THE HEMLOCK

DRB Recommendation Meeting
December 16, 2019
SDCI # 3033219

WH GREENWOOD, LLC

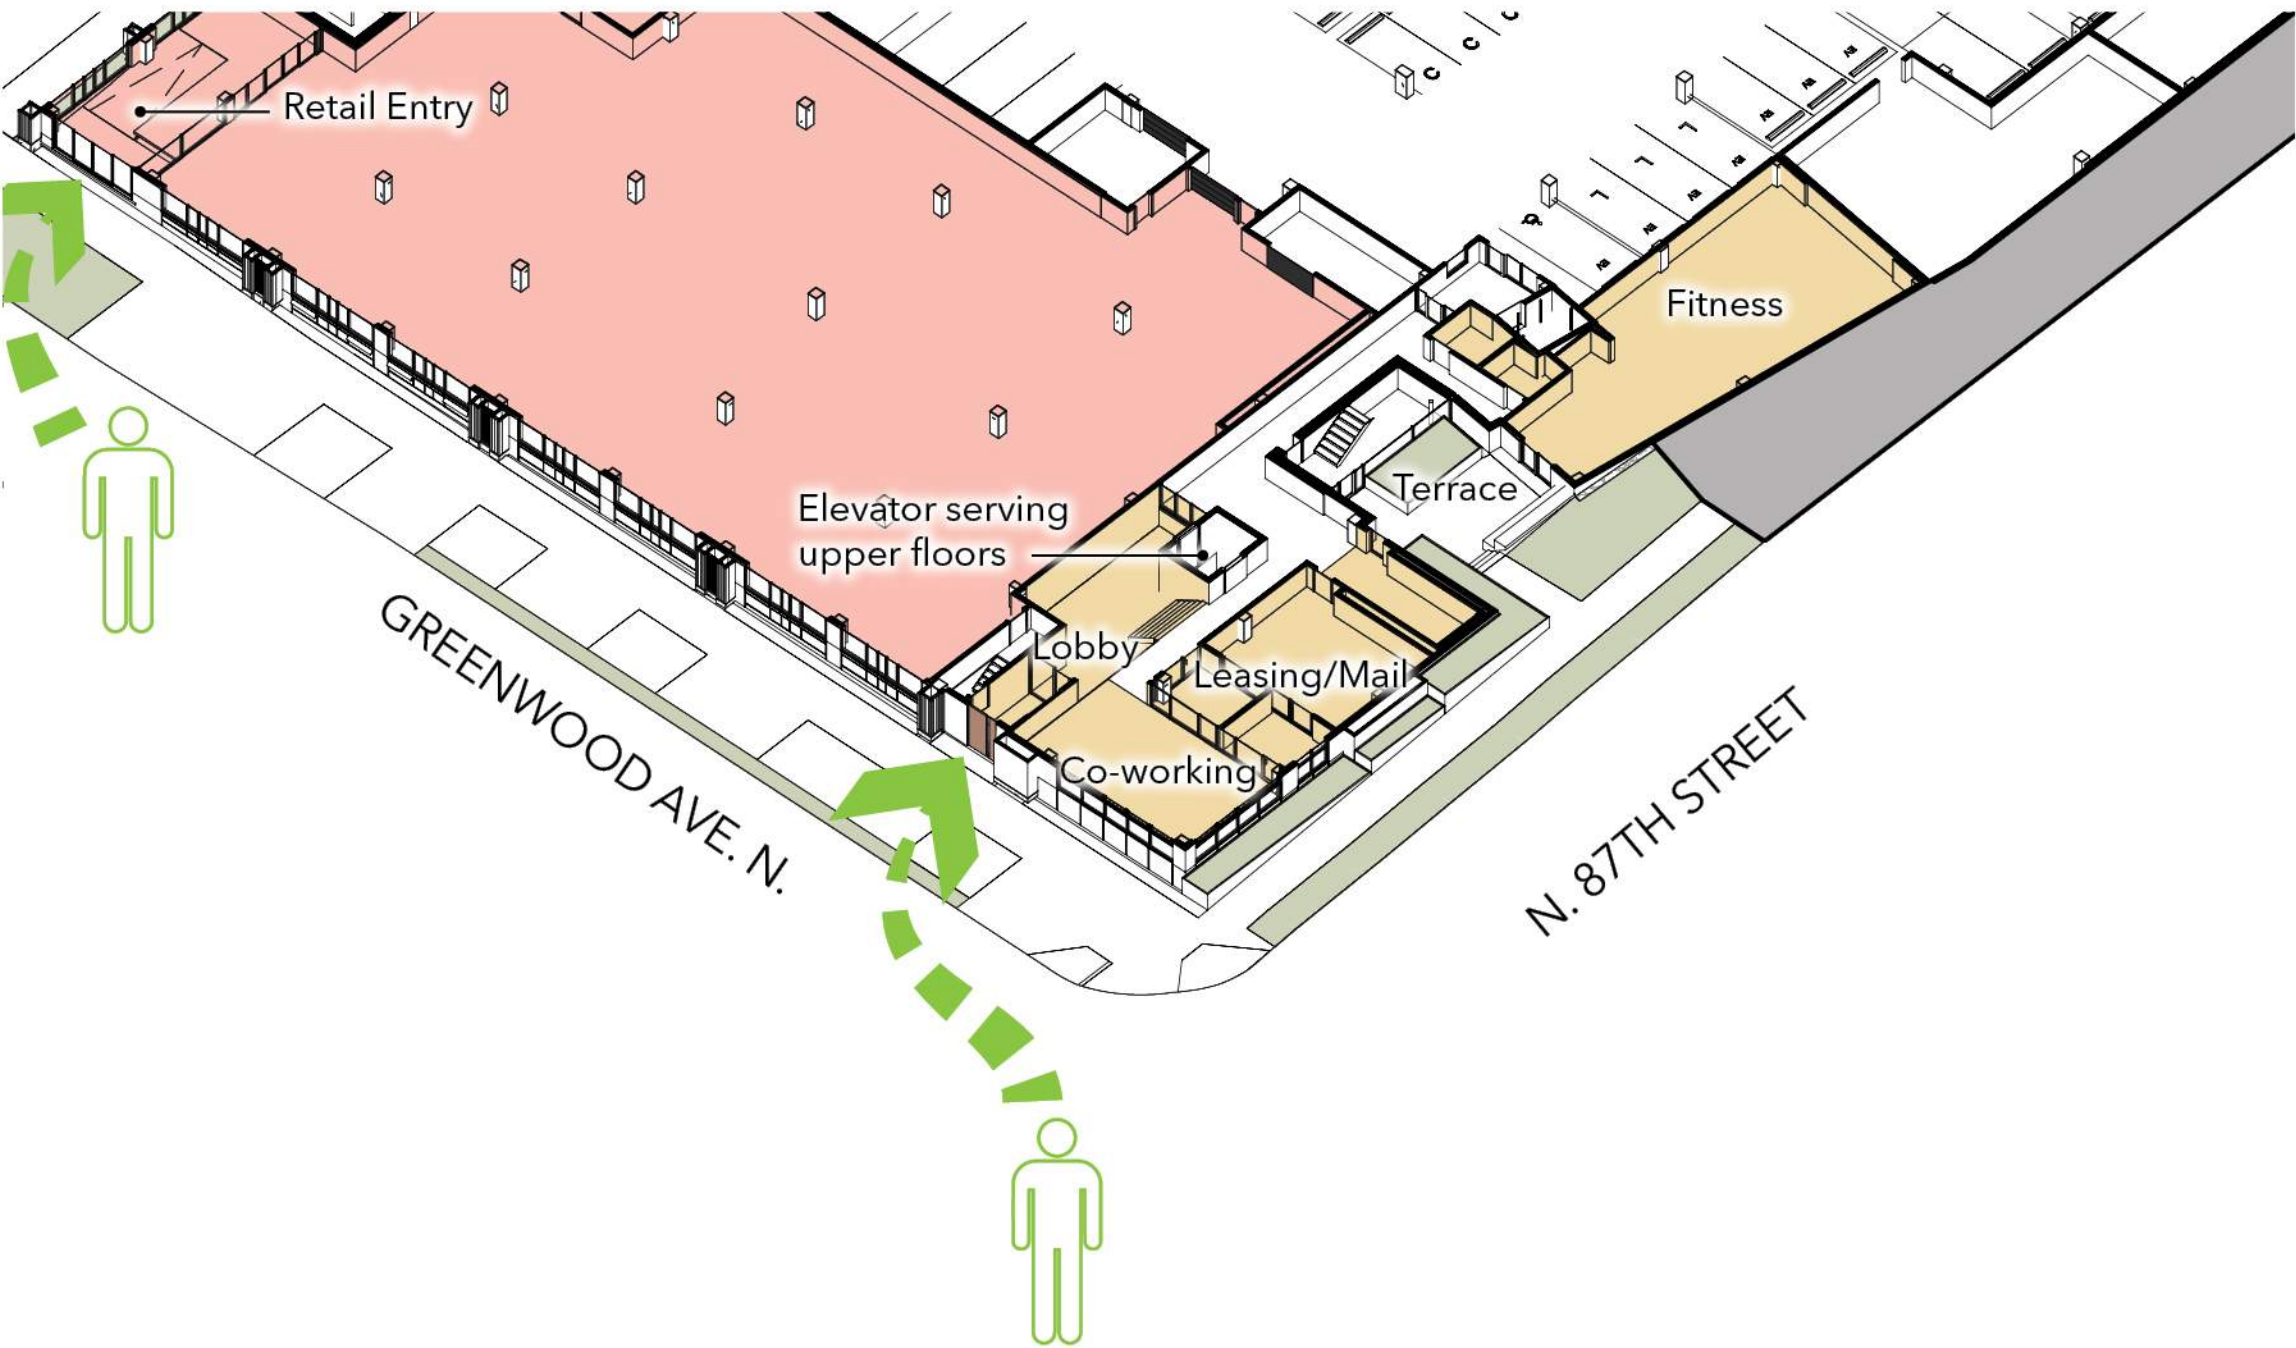
3c. The Board recognized the challenges presented by subsurface conditions and topography at this corner but agreed that engaging the street and creating opportunities for human interaction should be prioritized, citing the Flint Creek building as an appropriate precedent. (PL2-B-3)

Response:
The Citywide Design Guidelines (PL2-A-1) state,

The residential entry is located close to the corner in order to provide an accessible route to Level 1 (42" above the sidewalk) via a half-stop elevator. The Fair Housing Act and ADA require that the main entry of the building be on Greenwood. A ramp at this corner would be a cumbersome length and wheelchair lifts are not an inclusive design solution. Therefore, instead of locating the entry directly on the corner we have located it nearest the elevator that all building patrons can use, whether they have mobility disabilities or not.

GREENWOOD FACADE, BEFORE

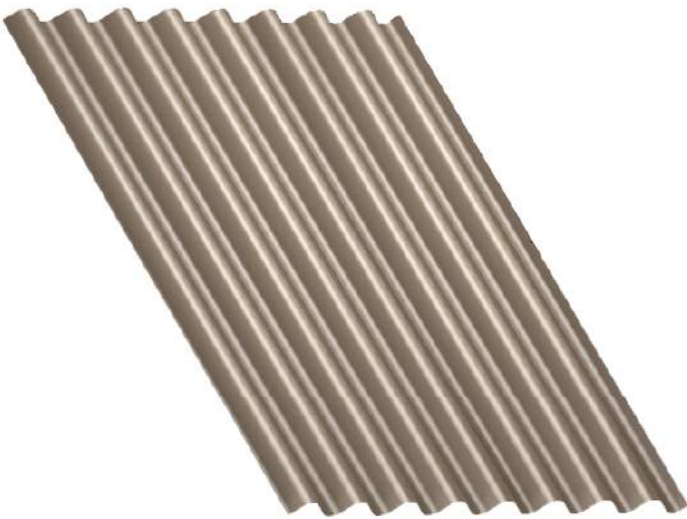
4a. The Board suggested carrying some of the first-floor bay organization through to the upper level, as well as organizing the fenestration pattern (by ‘ganging’ units together) to create a legible hierarchy. (DC2-B, CS3-II-i)

4c. The Board continued to support the idea of the horizontal gasket but had questions about its proportions relative to the larger facade and relationship to the ‘slot’ expression above the entry. (DC2, DC2-B)

4d. The Board agreed that the simplicity of the upper massing could strengthen the first two floors, but that it needed further development. (DC2)

Response:
The first floor bay organization has been carried through to the upper levels and unit windows have been ganged.

The proportions of the vertical slot have been refined to have a better relationship to the horizontal gasket.

The upper massing has been further developed.

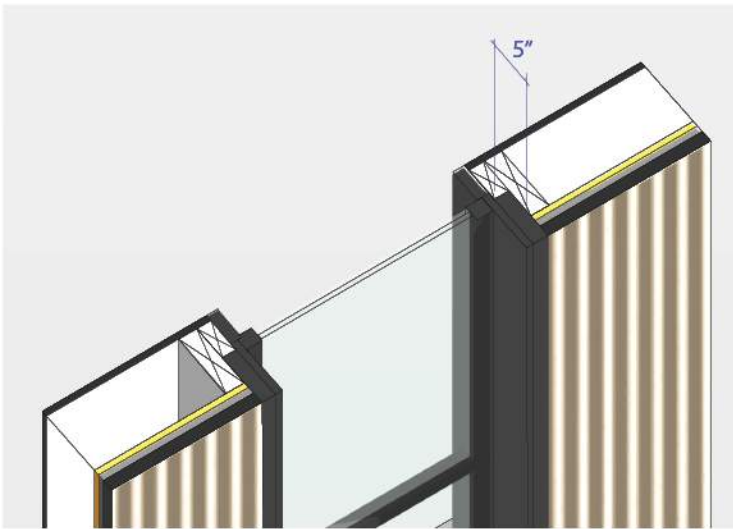
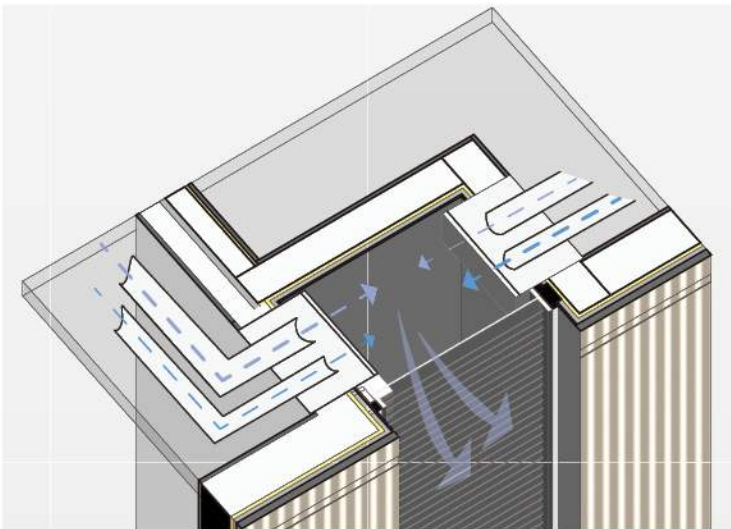
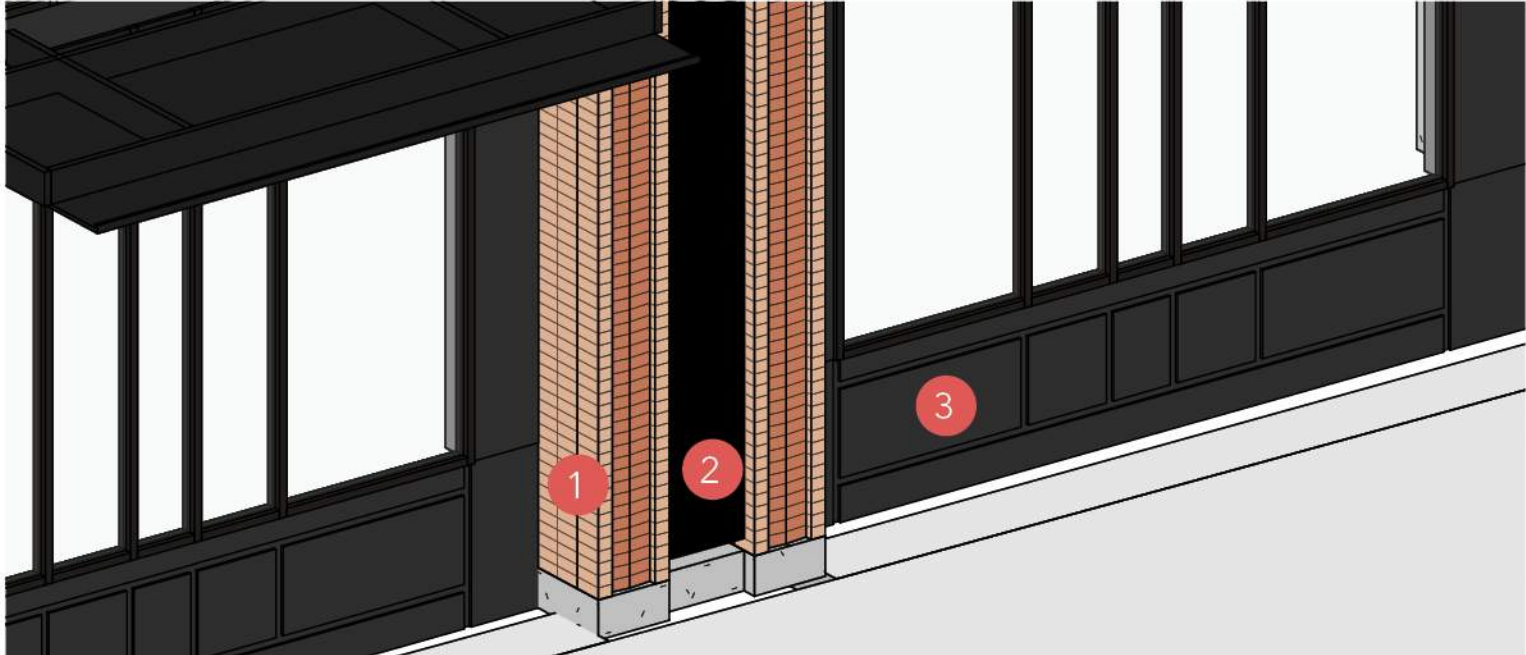
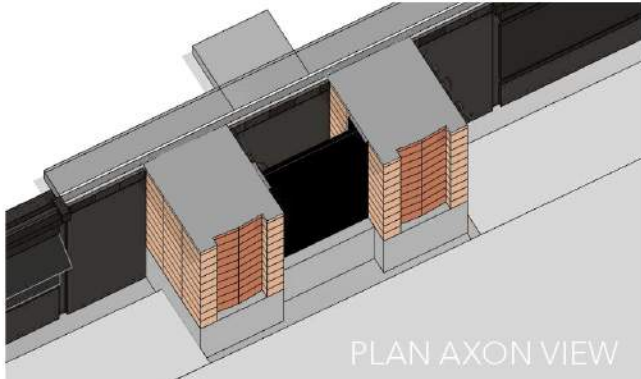
4b Echoing public comment regarding the flatness and lack of character of the upper massing, the Board gave guidance to explore the use of a cladding material with greater texture, and the development of window detailing that would create depth and shadow. (DC4-A-1, DC2-D-2)

Response:
Textured metal siding is now proposed at the upper massing. The windows are recessed in the facade to create a greater sense of depth and more defined shadow line. These design moves, along with the carefully articulated Level 1 facade and Level 2 "reveal" creates the "*fine-grained scale, or 'texture,' particularly at the street level*" that the Citywide Design Guidelines (DC2-D-2) suggest.

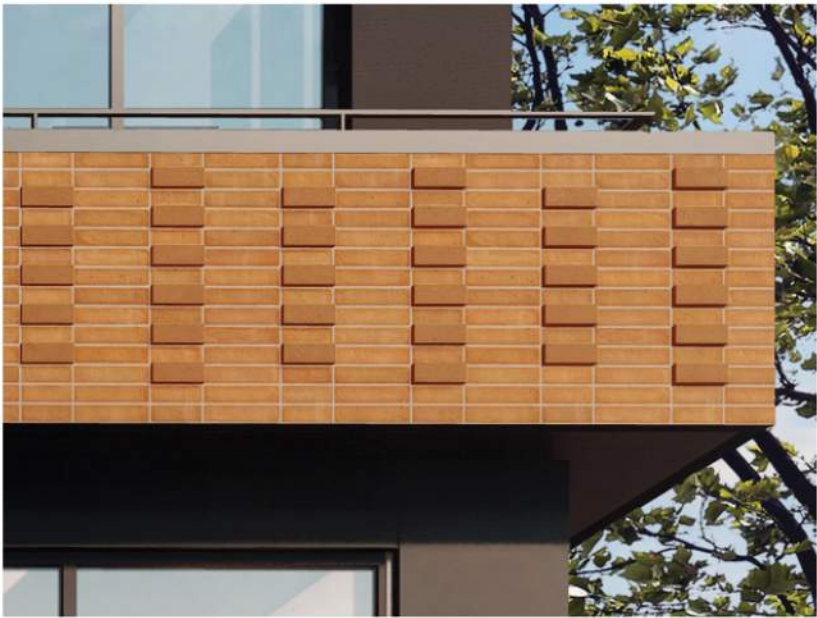
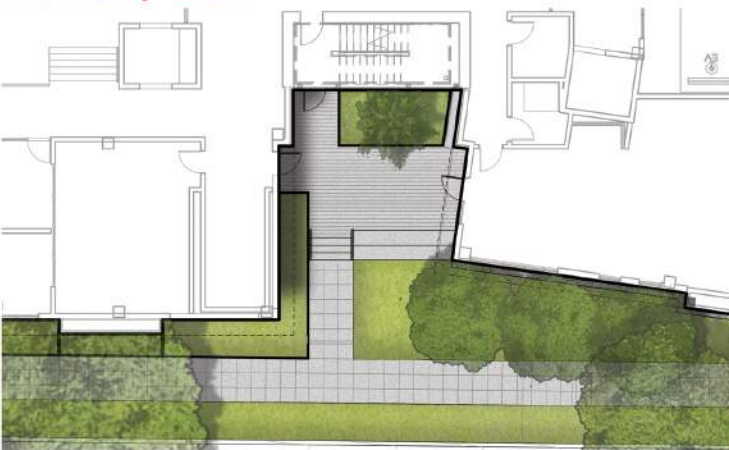
4f. The Board noted that the primary residential entrance is located in the narrowest bay on Greenwood and that although the ‘slot’ expression above would add emphasis, further development may be required to make the entry obvious, identifiable, and distinctive. (PL3-A-1)

4g. The Board agreed that the canopy over the residential entrance should be articulated differently than those over the other bays to strengthen and distinguish this entry. (PL3-A-1)

Response:
A canopy and custom signage mark the entry and make it appear obvious and distinctive.

The residential entry canopy is articulated differently than the retail canopies. A custom wood door is proposed at the residential entry. Custom signage incorporated in the building cladding is located north of the door.
